**Economic and Social Council**Distr.: General  
28 January 2013

**Economic Commission for Europe****Inland Transport Committee****World Forum for Harmonization of Vehicle Regulations****Working Party on Lighting and Light Signalling (GRE)****Sixty-Ninth session**

**Regulations Nos. 3, 4, 6, 7, 19, 23, 38, 65, 69,  
70, 77, 87, 91, 98, 112, 113, and 119****Proposal for Supplement 22 to the 02 series of amendments  
to Regulation No. 7 (Front and rear position lamps, stop-  
lamps and end-outline marker lamps)****Submitted by the expert from Germany\***

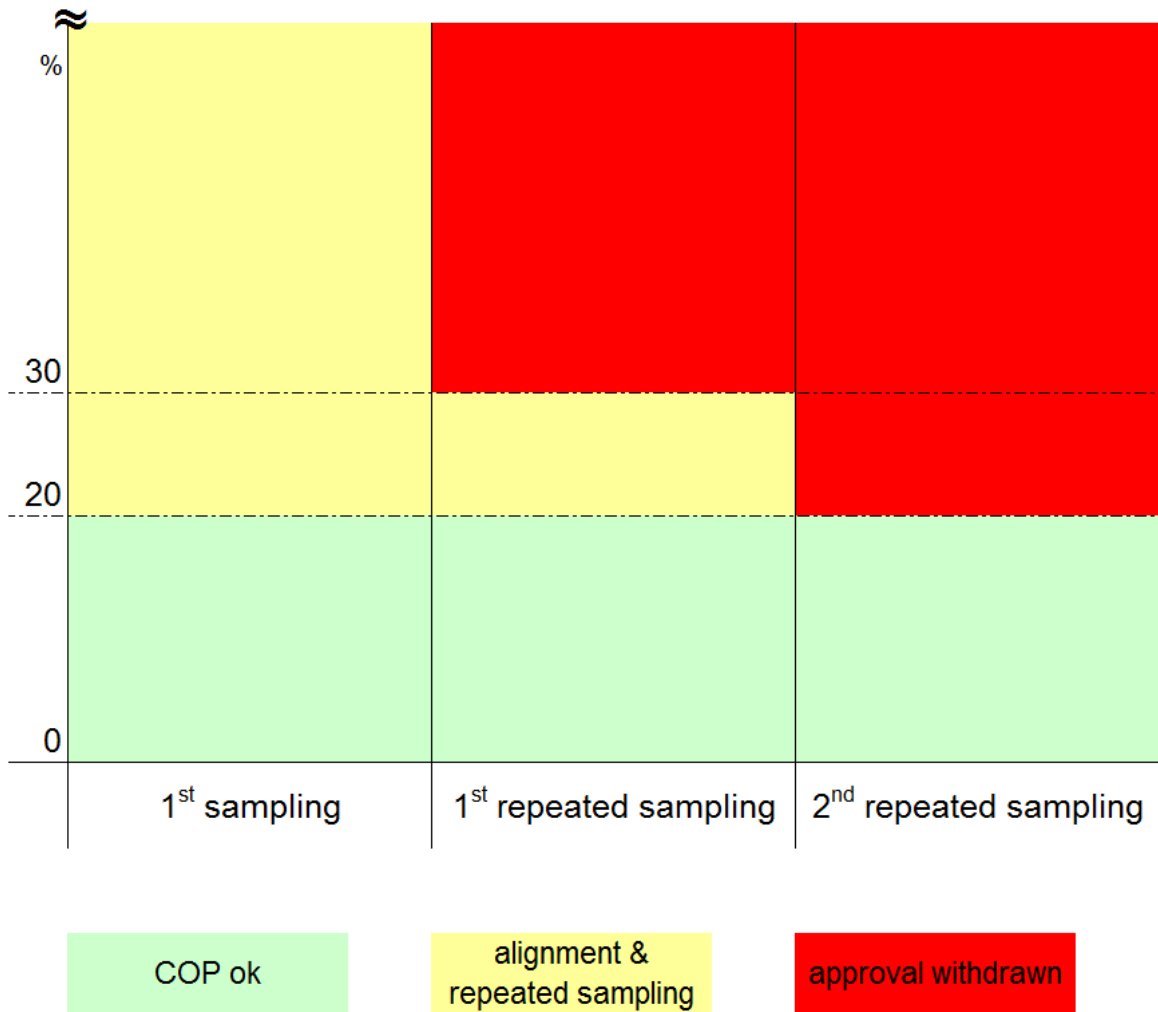
5. The relevant annexes on "Minimum requirements for sampling by an inspector" were completely restructured and simplified. All former examples which caused a great deal of confusion were deleted.
6. CoP is now described in a clear structured stepwise process (with limited steps), which gives the manufacturer the chance in the first step - in the case of deviations of more than 20 per cent - to align his production process. Also, the CoP process can be completed earlier when the first two samples are in the full specifications.
7. The proposal details the "third step" which defines the condition where the approval shall be withdrawn, when after the second repetition of this process the manufacturer was not in the position to "align" his production process in the correct way.
8. The attached drawing shall demonstrate this stepwise process.
